TOLEDO-LUCAS COUNTY PLAN COMMISSIONS

DATE: November 8, 2019
REF: SUP-9007-19

TO: President Matt Cherry and Members of Council, City of Toledo
FROM: Toledo City Plan Commission, Thomas C. Gibbons, Secretary
SUBJECT: Special Use Permit for a sweepstakes terminal cafe

SPECIAL USE PERMIT

SITE PLAN

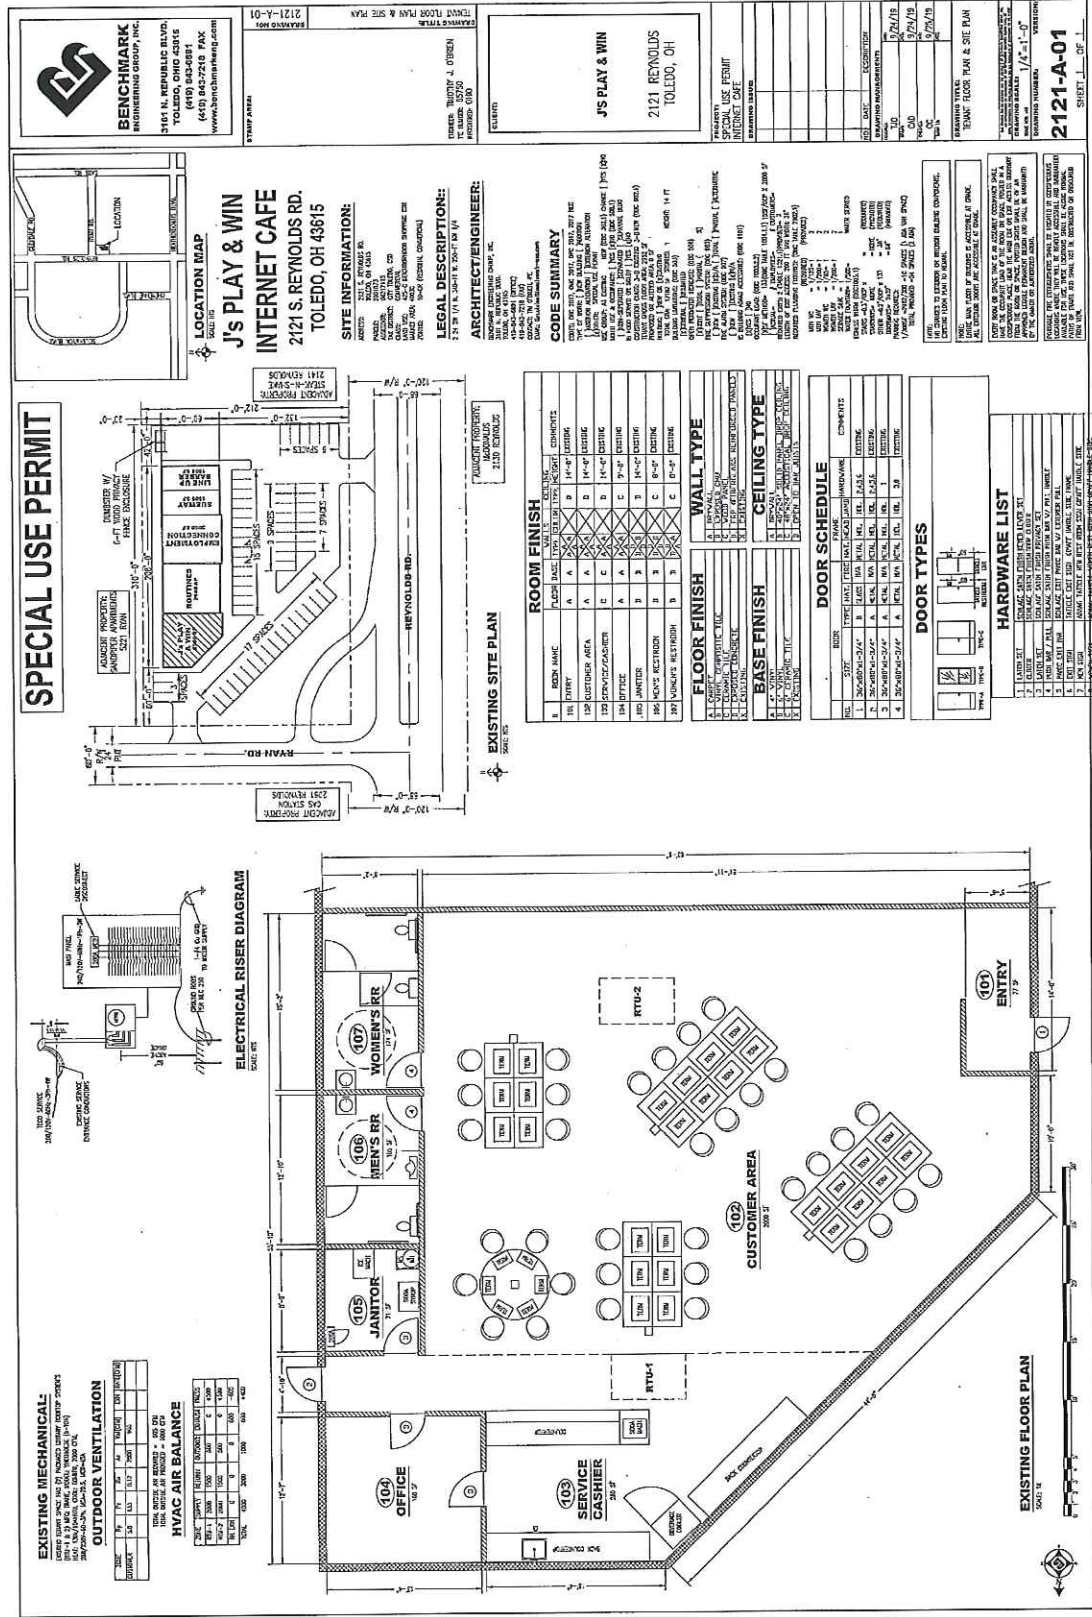
The parcel occupied by the multi-tenant building offers a total of fifty-four (54) parking spaces with two (2) being dedicated to handicap accessibility. The overall number of spaces offered is acceptable. Calculations conclude that a total of three (3) spaces are required. All new accessible parking spaces are required to be a minimum of 9' x 18' with a 5' aisle for auto and 8' aisle for van accessible parking per TMC 1107. Additionally, required spaces for persons with disabilities must be located in close proximity to building entrances and be designed to permit occupants of vehicles to reach the building entrance on an unobstructed path (TMC 1107.1703). Furthermore, all spaces reserved for the use by persons with physical disabilities shall adhere to the standards outlined in TMC§1107.1700. A revised site plan shall be submitted showing compliance with the location and markings of the handicap parking spaces and identifying the location and number of the bicycle parking slots.

23. Required spaces for persons with disabilities must be located in close proximity to building entrances and be designed to permit occupants of vehicles to reach the building entrance on an unobstructed path. **(Not acceptable as depicted on site plan).**

27. Bicycle parking slots shall be provided pursuant to Off-Street Parking Schedule "A" (TMC§1107.0300). Off-Street Parking Schedule "A" requires one (1) bicycle parking slot per ten (10) parking spaces. TMC§1107.0900(B) states: "When the provision of bicycle parking slots is required, the minimum number of slots provided shall be two (2)". **(Not depicted on the site plan).**

28. Whenever a parking lot extends to a property line, sidewalk, planting strip, or building, a wheel stop device consisting of a concrete stop, a permanent concrete curb, an expanded sidewalk or other suitable restraint as approved by the Planning Director must be installed to prevent any part of a parked motor vehicle from extending beyond the property line, overhanging a pedestrian walkway or sidewalk, or damaging any structure or landscaping (TMC§1107.1907(A)) **(Not depicted on site plan).**
